ADDENDUM NO. 5 TO PROJECT NO. 44124

**CONSTRUCTION WORK
REPLACE WINDOWS,
BUILDING NOS. 22 & 23
BEDFORD HILLS CORRECTIONAL FACILITY
247 HARRIS ROAD
BEDFORD HILLS, NY 10507**

January 13, 2012

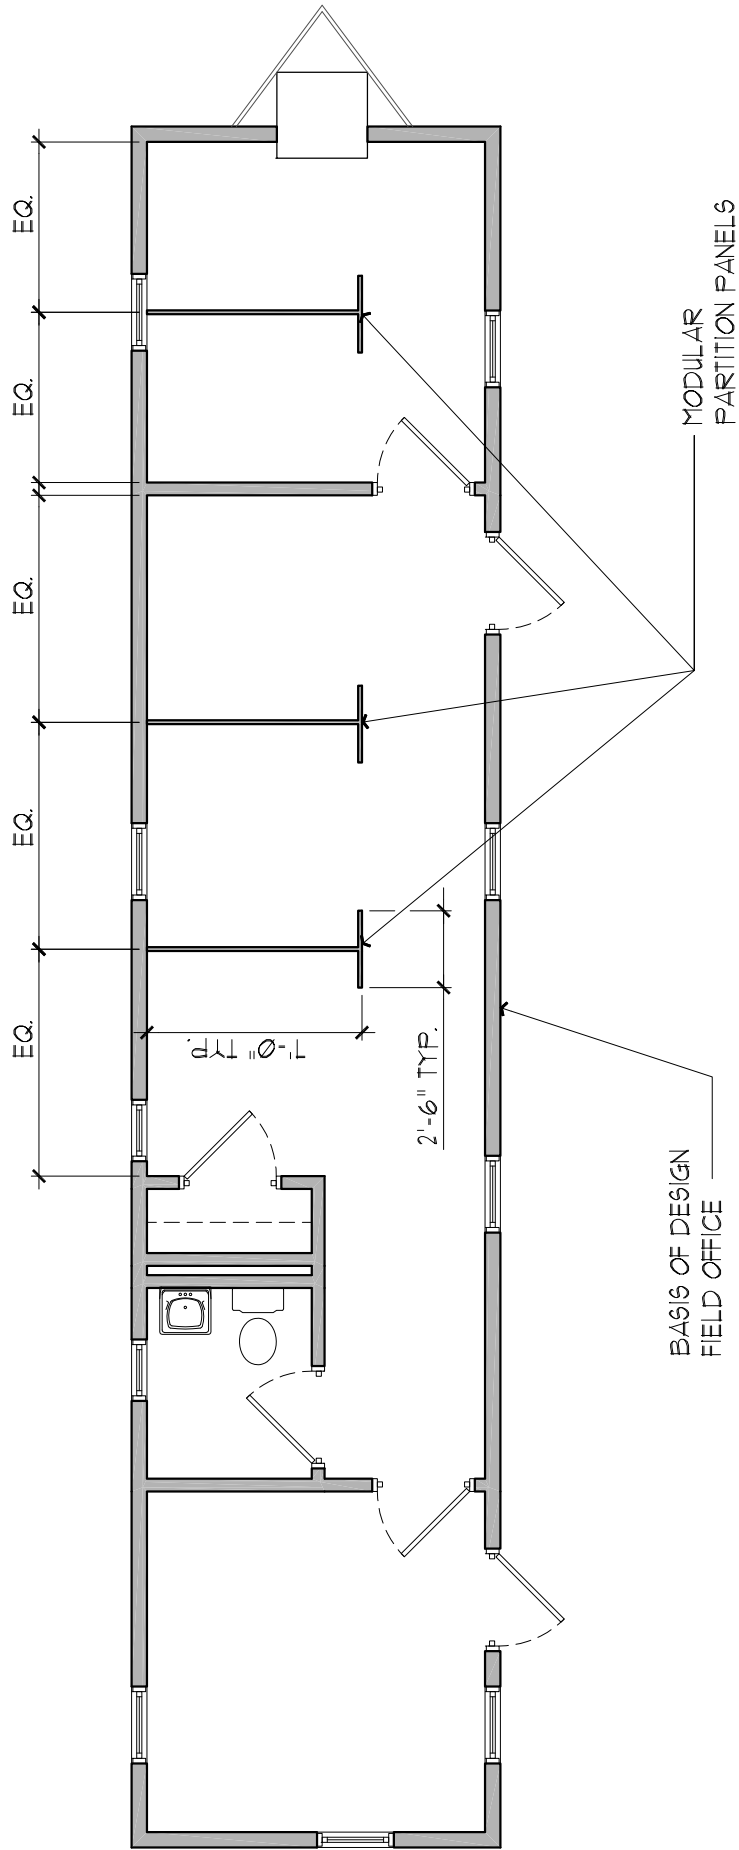
- H. Furnish and install insulated skirt around the bottom of the office unit. Skirt shall fully enclose the open area under the unit.
- I. Assemble and install modular partitions. Anchor to wall and floor.

MARK	DATE	DESCRIPTION
	01/13/2012	ADDENDUM 5
	09/16/2011	BID SUBMISSION
PROJECT NUMBER:	44124 - C	
DESIGNED BY:	THF	
DRAWN BY:	THF	
FIELD CHECK:		
APPROVED:		
SHEET TITLE:	OFFICE TRAILER LOCATION PLAN ADDENDUM DRAWING	
DRAWING NUMBER:	C-1.1	
SHEET	OF

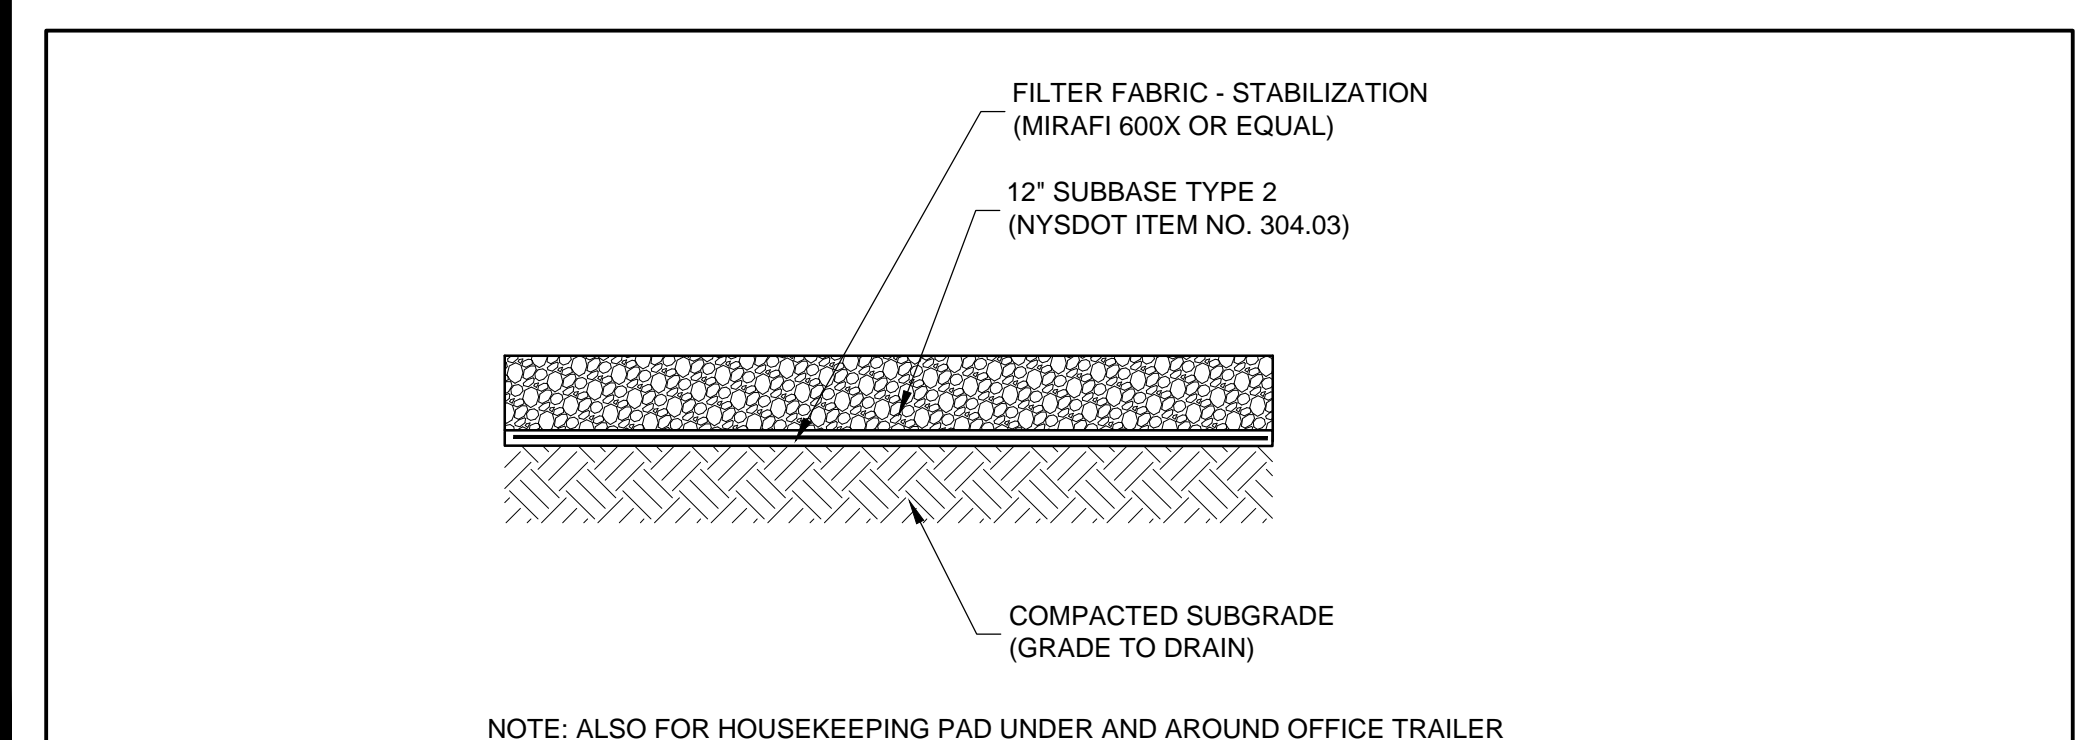
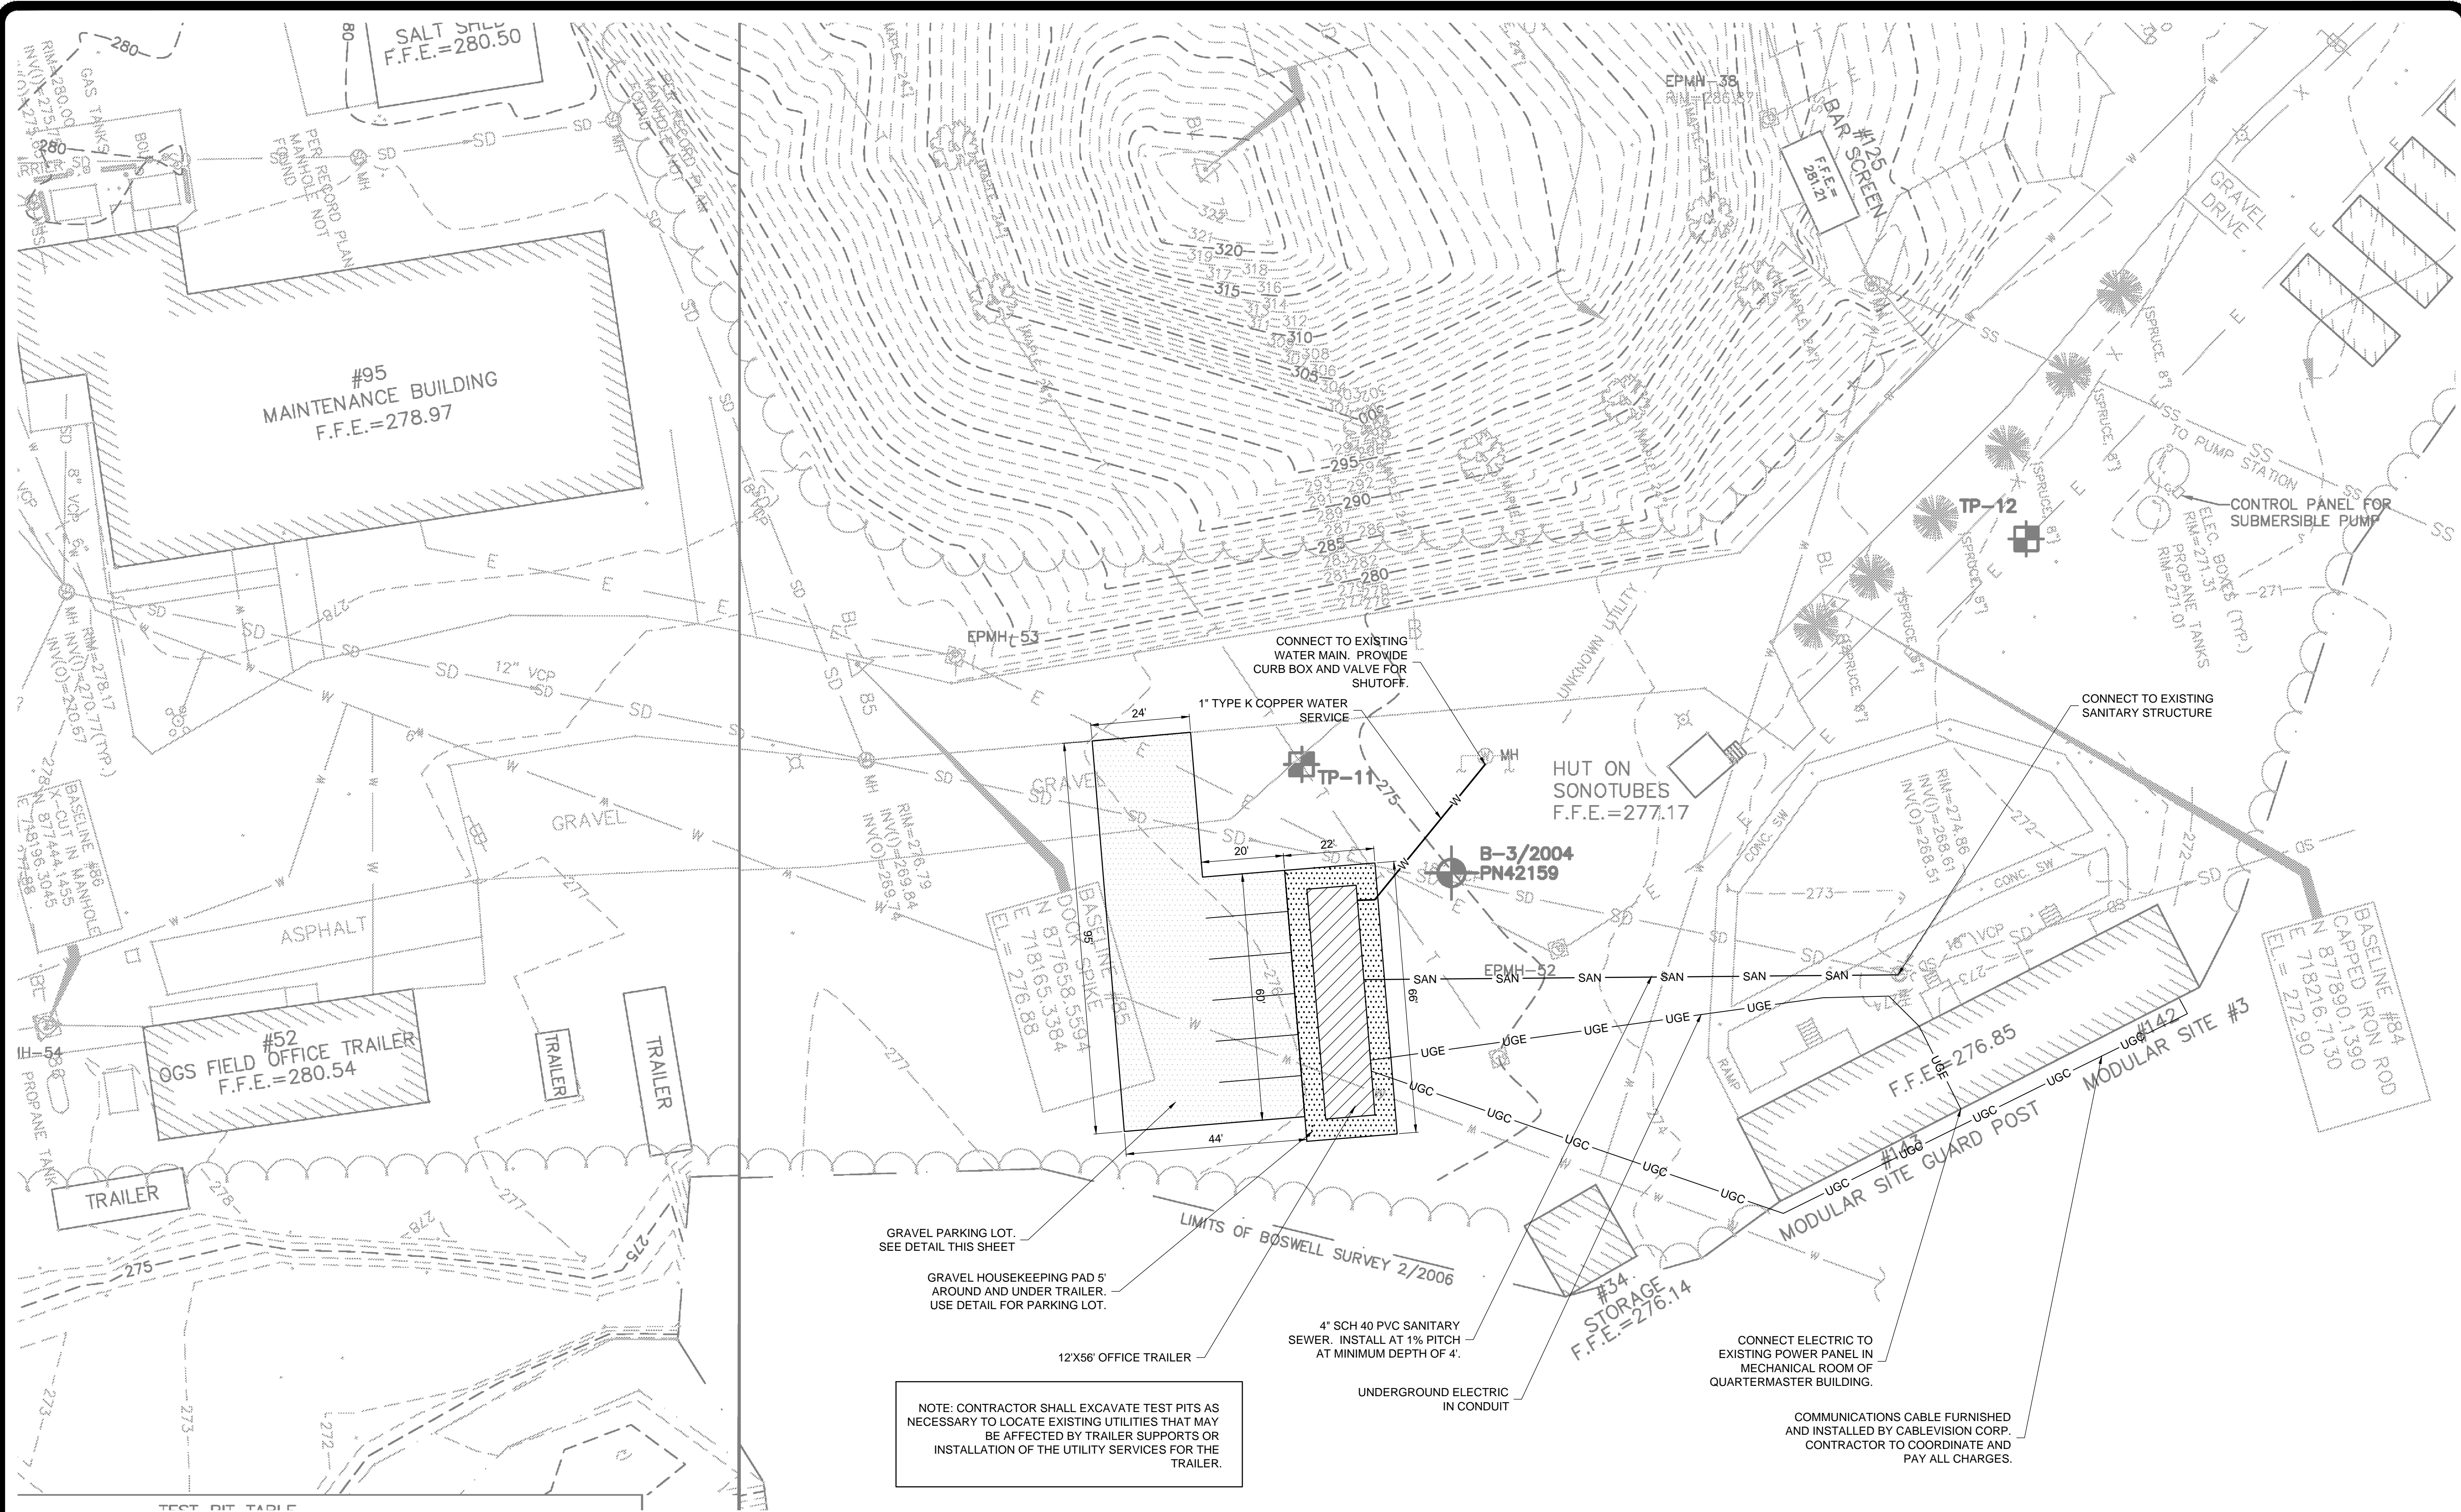
- 8. Addendum Drawing:
 - a. Drawing No. C1.1, titled “OFFICE TRAILER LOCATION PLAN ADDENDUM DRAWING” and dated 1-13-2012 accompanies this Addendum and forms part of the construction documents.
